**Response to the Examining Authority's
Further Written Question QE.2.5**

**Neighbours and Users of
Queen Elizabeth Park**

Interested Party reference no: **20022545**

(Farnborough Hill School, listed building shown in red, 140 metre distance to the Order Limits indicated with orange arrow)

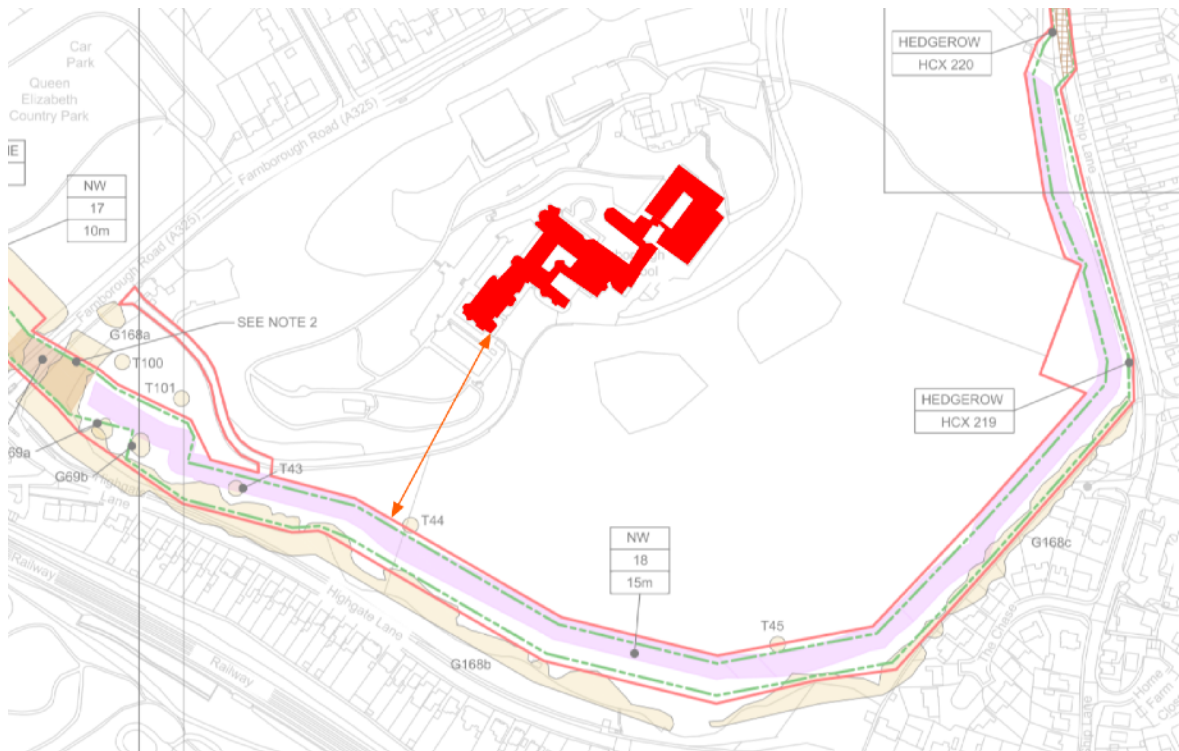
Esso's diagrams actually show two possible stringing areas which are mainly in, or very close to the Order Limits. Slight adjustment of the orientation of the reception pit could allow even better alignment of the stringing area substantially within the Order Limits.

We estimate that the smallest distance between the listed building and the Order Limits is about 140 metres. The works will be screened from view by trees and gradient changes. Threats to the structure are minimal and the risk of permanent damage to the setting is unlikely if the stringing area is carefully aligned.
